TECHNICAL EVALUATION REPORT

OVERRIDE AND RESET OF CONTROL CIRCUITRY IN THE VENTILATION/PURGE ISOLATION AND OTHER ENGINEERED SAFETY FEATURE SYSTEMS (B-24)

NORTH ANNA POWER STATION UNITS 1 AND 2

FRC PROJECT C5257

Figure 1. Containment Isolation Phase A/B

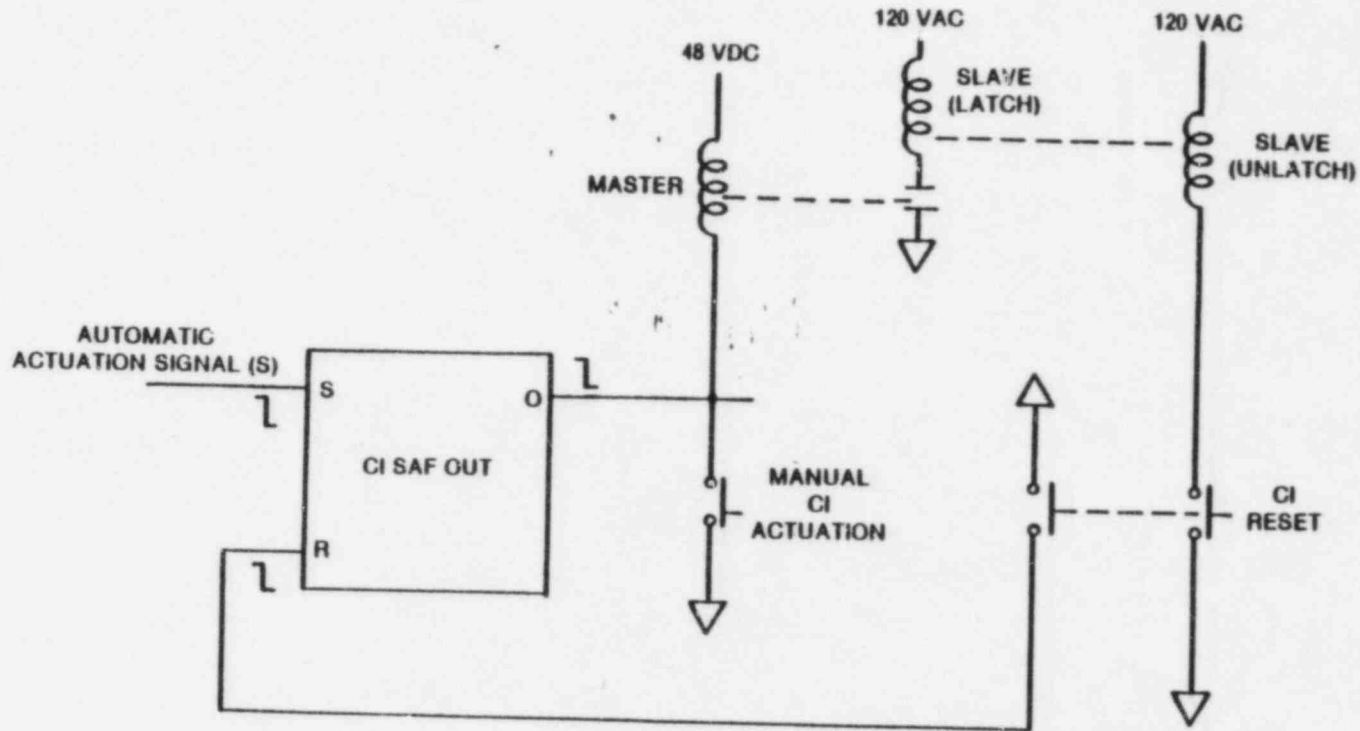
Containment isolation systems Phase A (CIA) and Phase B (CIB) are provided on each of two electrical trains, A and B. Safeguards actuation is initiated either by signals processed through the solid state protection system (SSPS) circuitry or by manual push buttons to operate a relay logic component actuation system as shown in Figure 1.*

Automatic containment isolation actuation signals are processed in a SAF-OUT board, consisting of a "resettable" solid-state latching circuit with a power conditioning output circuit, to energize a master relay coil. CIA and CIB manual actuation directly energizes the master relay coil. Master relay contacts control current flow to the latch coils of the associated latching-type (MG6) slave relays. Slave relay contacts are connected in the control circuits for the solenoid operators and motor operators used to position ESP valves and dampers. A manually operated "reset" switch (simple unprotected pushbutton) is provided with multiple contacts to operate the unlatch coils of the slave relay system and to provide a reset signal to the SAF-OUT board. This "reset" signal will de-energize the master relay and cause the SAF-OUT board to remain in a signal blocking (i.e., output signal removed and will not be reinstated by a new actuation signal) mode until the initiating signal has been removed. Thus, this "reset" feature performs as an override for processed input signals but will not preclude manual actuation of the master relay.

"Reset" switches provide for SAF-OUT devices employed in CIA and CIB are actually overrides which will block an output signal with an input signal present and will not allow reactivation by a second input signal unless the first signal has cleared. SAF-OUT devices for these systems are, however, actuated by a single parameter signal (safety injection actuation for CIA, high-high containment pressure for CIB).

No special physical features have been provided to facilitate administrative controls over the use of these overrides. The overridden status of these systems is not annunciated.

Figure 3. Typical Solenoid-operated Valve Control Circuits

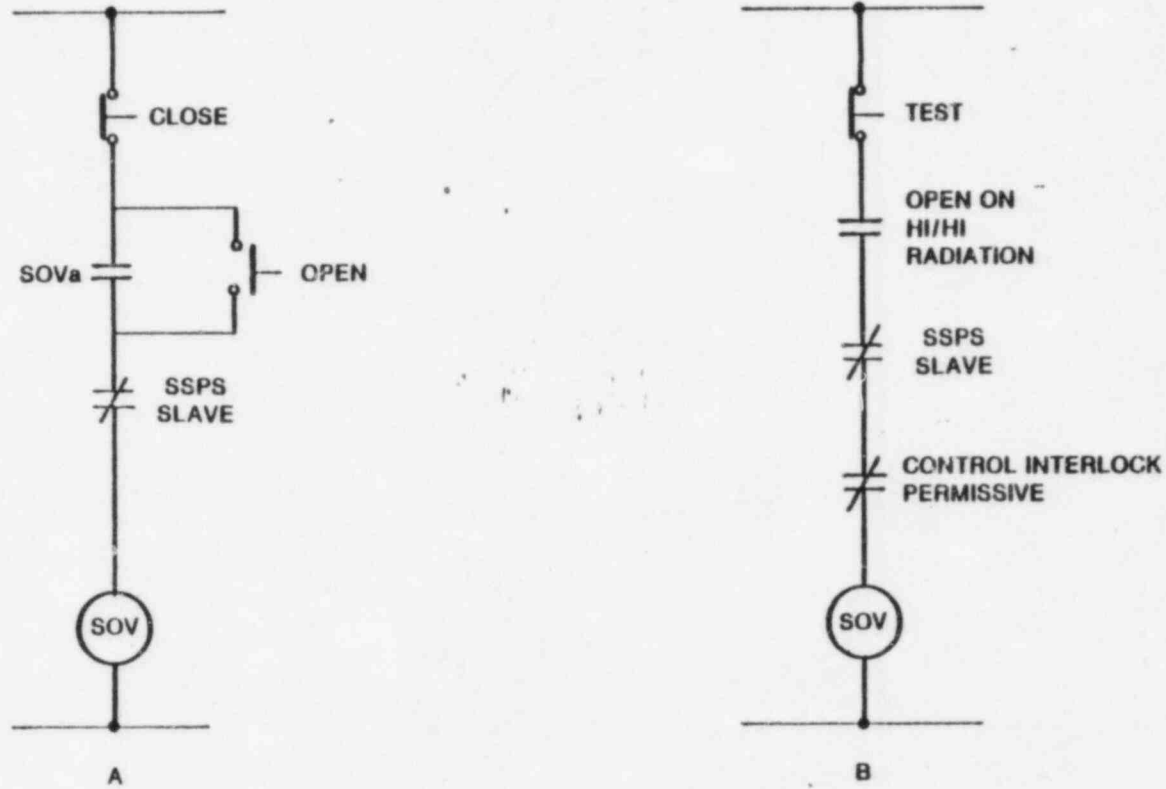
Solenoid valve control circuitry behaves similarly, as shown in Figure 3a. When the solenoid is energized (valve open), an auxiliary contact provides a circuit path around the open contact of the manual control switch. This network is connected in series with the contact from the slave relay. When a slave relay is energized, its contact in the valve control circuit opens to de-energize the solenoid. Upon "reset," the slave relay contacts reclose, but the solenoid remains de-energized since both the manual switch contact and the solenoid auxiliary contact remain open.

The single instance observed during the audit of Licensee-supplied circuit diagrams associated with CIA and CIB where a valve will change position upon reset was the air ejector vent to atmosphere. As shown in Figure 3b, the slave relay contacts are in a simple series arrangement with the solenoid (i.e., without any auxiliary hold in contact).

An audit of valves actuated by CIA and CIB has revealed one valve (air ejector vent to atmosphere) which will reposition upon ESF "reset" (i.e., override). This valve is not a containment isolation valve in the accepted sense of the term (e.g., 10CFR50 Appendix J). It isolates the noncondensable gas discharge from the air ejector after condenser. The auxiliary steam supply to the air ejector is tripped shut by CIA and will not change position upon CIA reset. Further, the air ejector vent isolation valve is normally (i.e., unless tripped by CIA) controlled by a high radiation signal and can be open only when a high radiation signal is not present. This feature shuts the isolation valve when required by plant conditions (i.e., high radioactivity in the condenser).

"Vepco does not intend to make any changes under Criterion 6 concerning the circuitry for the air ejector vent to atmosphere isolation valves, since the present circuitry receives a high radiation signal and a containment isolation Phase A signal even

though this valve is not a containment isolation valve. For this circuit, if containment isolation were reset and there was a high radiation condition, the air ejector vent to atmosphere isolation valves would remain closed. If no high radiation condition were present, no detrimental situation would be encountered if the valve opened after resetting containment isolation."

- o Air Ejector Vent to Atmosphere Isolation Valves - The present circuitry is considered to be an acceptable deviation from Criterion 6.

Figure 4. Feedwater Control Logic

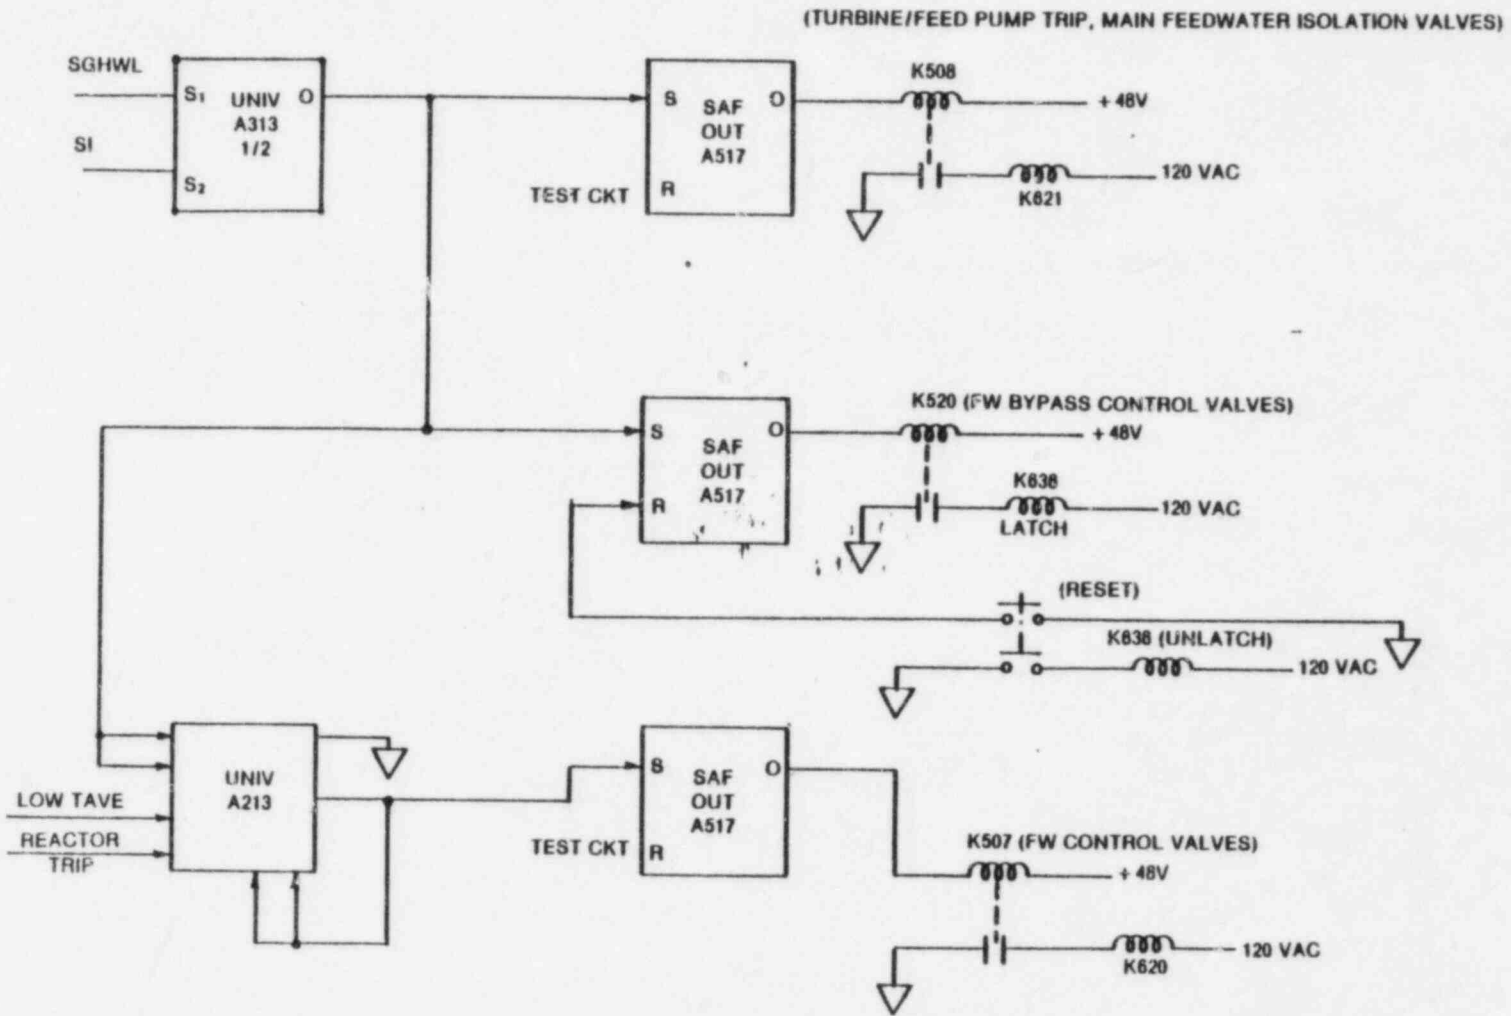
The feedwater isolation system, shown in Figure 4, is formed from a complex of subsystems operating on three groups of components (i.e., turbine and main feed pumps, bypass control valves, and feedwater control valves). The main feedwater isolation valves are part of the first group. Each of these groups will be actuated by either high steam generator water level (control system trip) or safety injection. In addition, the feedwater control valves will be closed by low T avg coincident with reactor trip.

Pushbutton-type switches are provided for the SAF-OUT devices employed in the containment spray system and feedwater bypass valve subsystem of the feedwater isolation system. The containment spray SAF-OUT device is actuated by a single parameter signal (i.e., high-high containment pressure) and thus poses no violation of Criterion 1. The feedwater bypass valve SAF-OUT device, however, is actuated by either of two parameters (i.e., safety injection actuation or high-high steam generator water level) and, since the overriding of one signal will block the other, constitutes a violation of Criterion 1.

An audit of valves actuated by containment spray and feedwater isolation systems has revealed two groups of valves which will reposition upon ESF "reset." Both the feedwater flow control valves and the feedwater bypass valves will return to their modulate (i.e., that dictated by the controller) position when associated slave relays de-energize.

In the case of the feedwater bypass valves, repositioning will follow a single operator action (depressing the feedwater bypass valves blocked "reset" pushbutton), regardless of the status of isolation signals. Further, the reopening of these valves, since they bypass the feedline isolation valves, results in there being only two valves (the feed pump discharge valve and the feedline check valve) between the feed pump and the steam generator. In the unlikely situation of the failure of the feed pump to trip in response to the isolation signal, only the check valve will remain, and steam generator feed will occur should the bypass valves be open.

Circuitry provided for the control of the feedwater bypass valves does not satisfy Criterion 1. The "reset" provided at the SSPS SAF-OUT board for this subsystem is actually an override. The override will terminate an output signal and block system actuation by a second input signal until the first is cleared.

"A two position, "Normal - S/G Wet Layup" keylock switch located in each Train A and B system protection rack will be added to the FW bypass valve circuitry such that when the switch is in the "Normal" position (station in any operating mode except cold shutdown or refueling) the FW bypass valve reset switch will not permit opening the valves until the trip signal is cleared. When the station is preparing to place the steam generators in wet layup, the above mentioned keylock switch will be placed in the "S/G Wet Layup" position which will allow the FW bypass reset switch to perform its reset function. In this case, the signal being blocked (Hi-Hi SG level) is not considered to be a safety signal. Keylock switch operation will be administratively controlled in the Station's Operating Procedures."

The proposed keylock switch, a two-position switch to be located between the pushbutton contact and the R input to the bypass control valves SAF-OUT device, will prevent an override of the SAF-OUT device when open. With this switch open, depressing the reset pushbutton will unlatch the bypass control valve subsystem slave relay (K636), allowing the slave relay to change position if the master relay (K520) is de-energized. With a continuous open at the R input, the SAF-OUT device acts as a non-inverting driver, de-energizing the master relay only when all input signals are cleared. This modification, combined with the Licensee's provisions to ensure that the proposed keylock switch will be closed only during cold shutdown or refueling, meets the intent of Criterion 1.

Figure 5. Feedwater Solenoid-operated Valve Control Circuits

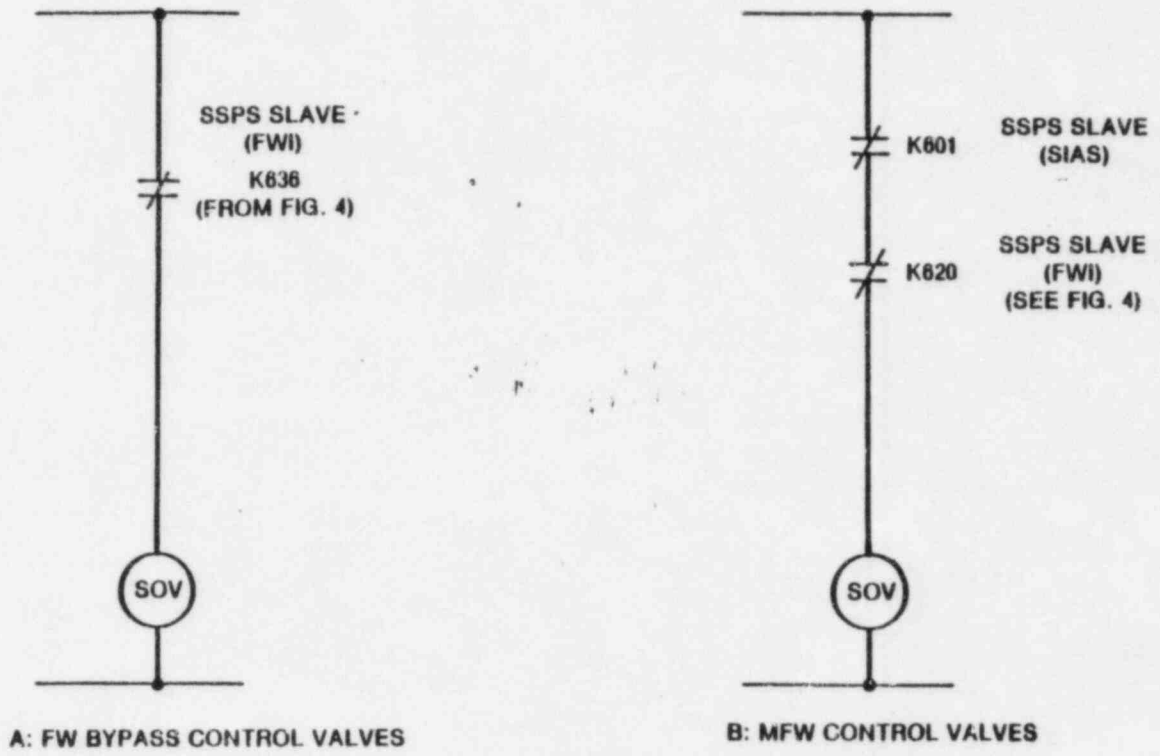
In general, motor- and solenoid-operated valve control circuits in the containment spray and feedwater isolation systems are designed to preclude valve repositioning upon reset or signal clearance. These systems use control circuitry fundamentally equivalent to that described in Section 3.2.1.2 and shown in Figures 2 and 3a. Two exceptions were noted. Circuits for the feedwater bypass control valves, illustrated in Figure 5a, and feedwater flow control valves, shown in Figure 5b, are designed so that these valves will be restored to their modulate position (i.e., position called for by the feedwater control system) when the appropriate slave relay is de-energized.
